Client:	Akelius	Drawing Title:	Tree Survey & Constraints Plan
---------	---------	----------------	--------------------------------

14 Greencroft Gardens, London, NW6 3LS

Date:	19/09/19	Drawn By:	KFJ	CAD File Ref:	C:\Pro\7678-D-CP - 14 Greencroft Gardens.dwg
Scale:	1:200	Checked By:	CS	Drawing No.:	7678-D-CP
Rev:	-

Existing Site Plan

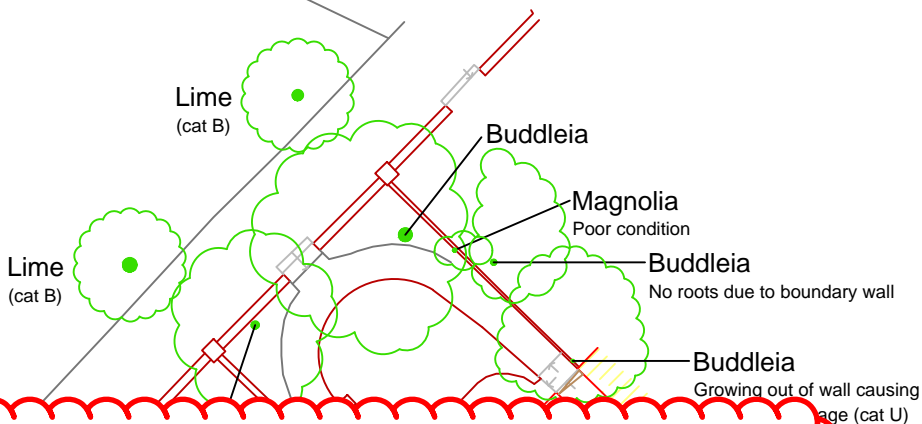
Suggested location of re-aligned wall (red-dashed line). To ensure the best chance of this being looked upon favourably by the LPA, the existing wall should be demolished and the foundations retained from ground level. This will ensure no roots are damaged. The new wall should be constructed on a pad and beam foundation (or similar) to ensure any damage to roots is kept to a minimum and the base of the wall can sit at ground level once the existing concrete slab has been removed. A detailed design will be required for inclusion within the report to demonstrate no notable damage will occur as a result of its construction. The area behind can then be backfilled with porous material.

T002 and T003. It is not expected that any objections will be raised to the removal of these two Laurels. They will be identified for removal within the report.

The existing soil levels behind the existing wall must remain as they are (purple area).

The replacement final surfacing (within yellow area) must be porous. It is also recommended that it is laid onto a 50mm deep cellular confinement system to ensure a favourable rooting environment is created.

It will be recommended within the report that Lime T001 is re-pollarded at the established points identified on the attached photo. It is not expected that any objections will be raised to these works.
